Project	IEEE 802.16 Broadband Wireless Access Working Group < http://ieee802.org/16 >
Title	Modified LDPC Matrix providing improved performance
Date Submitted	2004-05-15
Source(s)	Brian Classon, Yufei Blankenship 847-576-5675 Motorola Brian.Classon@Motorola.com
Re:	802.16e D2
Abstract	New LDPC matrix providing improves performance for shortened codes
Purpose	Replace text in previous LDPC proposal: "Draft text for LDPC coding scheme for OFDMA"
Notice	This document has been prepared to assist IEEE 802.16. It is offered as a basis for discussion and is not binding on the contributing individual(s) or organization(s). The material in this document is subject to change in form and content after further study. The contributor(s) reserve(s) the right to add, amend or withdraw material contained herein.
Release	The contributor grants a free, irrevocable license to the IEEE to incorporate material contained in this contribution, and any modifications thereof, in the creation of an IEEE Standards publication; to copyright in the IEEE's name any IEEE Standards publication even though it may include portions of this contribution; and at the IEEE's sole discretion to permit others to reproduce

Figure 1. Block Diagram of one possible encoder for specified LDPC code.

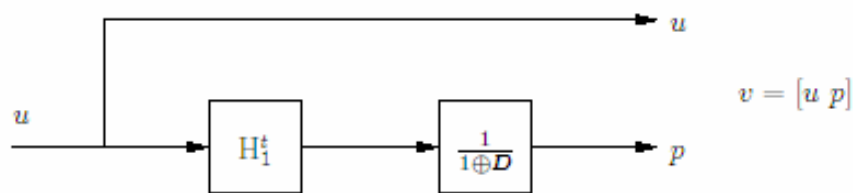
In section 8.4.9.2.4.2 LDPC encoding:

Delete the text:

However, for this code H_2 is simply $f(D) = 1 + D$, and hence H_2^{-t} can be implemented by a differential encoder. One possible encoding process is then

Equation 1

$$v = [u \mid uH_1^t H_2^{-t}] = \left[u \mid uH_1^t \frac{1}{1+D} \right]$$

and is illustrated in Figure 1.

For the described code H_1 is low-density, with a uniform column weight of four.

Replace with:

However, for this code H_2 has a simple deterministic structure, and encoding can be performed recursively. H_2 is composed of two parts. The weight 3 first column $\mathbf{h} = [h_0, h_1, \dots, h_{m-2}, h_{m-1}]^T = [1 \ 0 \ 0 \ 0 \ 1 \ 0 \ 0 \ 0 \ 1 \ 0 \ \dots \ 0]^T$. The rest of the columns (denoted by the m -by- $(m-1)$ matrix \mathbf{H}'_2 , where $m=n-k$) are weight-2 with maximum of 1 overlap between each other: \mathbf{H}'_2 has matrix elements equal to a 1 for $i=j$ and a 1 for $i=j+1$, and a 0 elsewhere, for row i , column j of \mathbf{H}'_2 , $0 \leq i \leq m-1$, $0 \leq j \leq m-2$.

$$\begin{aligned}
 \mathbf{H}_2 &= [\mathbf{h} \quad \mathbf{H}'_2] \\
 &= \left[\begin{array}{c|cccccccc}
 h_0 & 1 & & & & & & \\
 h_1 & 1 & 1 & & & & & \\
 \cdot & & 1 & 1 & & & \mathbf{0} & \\
 \cdot & & & 1 & 1 & & & \\
 \cdot & & & & 1 & 1 & & \\
 \cdot & & & & & 1 & 1 & \\
 \cdot & & \mathbf{0} & & & 1 & 1 & \\
 \cdot & & & & & 1 & 1 & \\
 \cdot & & & & & & \ddots & \ddots \\
 \cdot & & & & & & & 1 & 1 \\
 h_{m-1} & & & & & & & 1 & 1 \\
 & & & & & & & & 1
 \end{array} \right].
 \end{aligned}$$

Given any block of information bits \mathbf{s} , the m parity-check bits can be found by

$$p_0 = \left(\sum_{\text{row}} \mathbf{H}_1 \right) \mathbf{s}^T,$$

where $\sum_{\text{row}} \mathbf{H}_1$ denotes the row vector after summing up all rows of \mathbf{H}_1 . Note that the summation can equivalently be performed on the intermediate column vector $v = [v_0, v_1, \dots, v_{m-1}]^T = \mathbf{H}_1 \mathbf{s}^T$, but performing the summation on the rows of \mathbf{H}_1 can be done beforehand and results in fewer operations to compute p_0 .

With p_0 determined, the rest of parity check bits, p_1 through p_{m-1} can be found recursively. For example,

$$\begin{aligned}
 p_1 &= h_0 p_0 + v_0, \\
 p_2 &= h_1 p_0 + p_1 + v_1, \\
 p_3 &= h_2 p_0 + p_2 + v_2, \\
 &\dots \\
 p_{m-1} &= h_{m-2} p_0 + p_{m-2} + v_{m-2}.
 \end{aligned}$$

To simplify implementation, a vector $w = [h_0 p_0 + v_0, h_1 p_0 + v_1, \dots, h_{m-2} p_0 + v_{m-2}]$ can be stored so that the parity bits are found by $p_1 = w_1, p_i = p_{i-1} + w_{i-1}, 1 \leq i \leq m-1$. The structure in \mathbf{h} can be used to further reduce encoding complexity since most entries of \mathbf{h} may be the trailing zeros (e.g., $\mathbf{h} = [1 \ 0 \ 0 \ 1 \ 0 \ 0 \ 1 \ 0 \ \dots \ 0]^T$). Knowing that all values of h_i are 0 for $z \leq i \leq m-1$ can simplify the step of determining the parity-check bits recursively. In one example, $w_i = v_i$ for $z \leq i \leq m-1$, thus $p_i, z \leq i \leq m-1$, can be found before finding p_0 . Then p_0 through p_{z-1} can be found based on \mathbf{s} and p_z .
